MODEL
2020MY
Telluride (ON)

NUMBER
193

TECHNICAL SERVICE BULLETIN

SUBJECT: CROSS BAR KEY COVER
SERVICE PART/REPLACEMENT

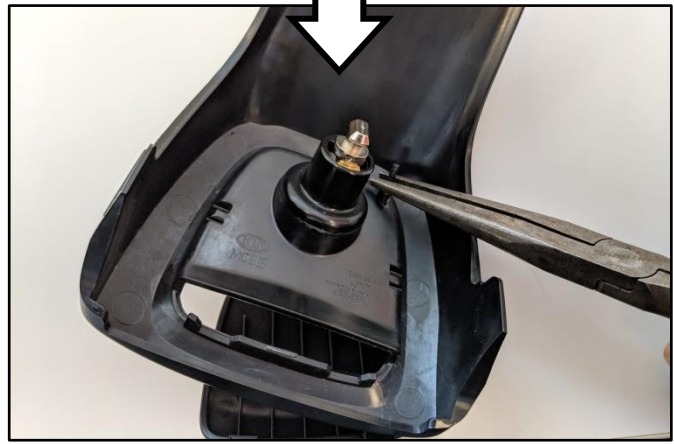
- 6a. Take the new updated cross bar key cover and feed the attached tether in through the front upper left hand hole of the cross bar end cap.

- 6b. On the reverse side of the cross bar end cap, pull the key cover plastic tether through the hole using a set of pliers to retain the key cover to the end cap.
